# Legalelectric, Inc.

RE: NoCapX Comments on DEIS  
CapX 2020 **Hampton-Rochester-LaCrosse** Transmission Project  
PSC Docket No.: 05-CE-136

Thank you for the opportunity to submit comments on this Draft Environmental Impact Statement for the CapX 2020 Hampton-Rochester-LaCrosse Transmission Project.

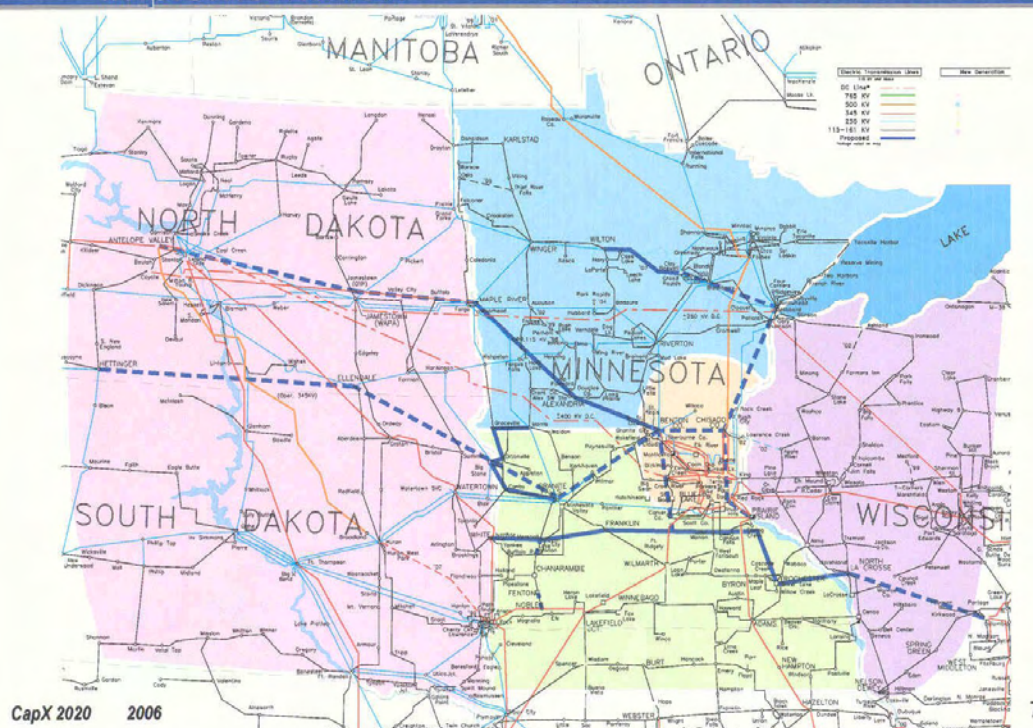
p. 24 – the DEIS states that “applicants also emphasize that the proposed project would prove pivotal for future expansion...” This section must disclose the full “CapX 2020 Vision Plan” together with the map showing the Phase I CapX 2020 projects and the chart of the CapX 2020 Vision Plan:

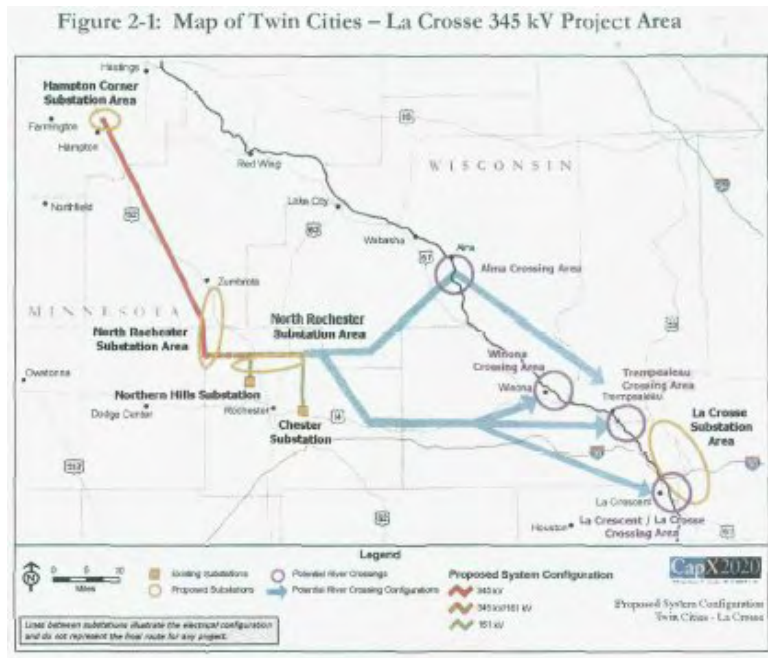
First, the statement that “*If the comments from the task forces and the public did not indicate that the LaCrosse crossing should be reevaluated in addition to the Alma crossing, then the scope of the Minnesota EIS would include the Alma crossing as the only crossing*” **is not true and is a gross misrepresentation of the Minnesota record** Also, this statement is not supported by the DEIS citation to the FEIS Executive Summary, “Section 6” and/or any documents in the record in Minnesota. Many comments were made requesting that more than one Mississippi River crossing be considered. These comments are documented below.
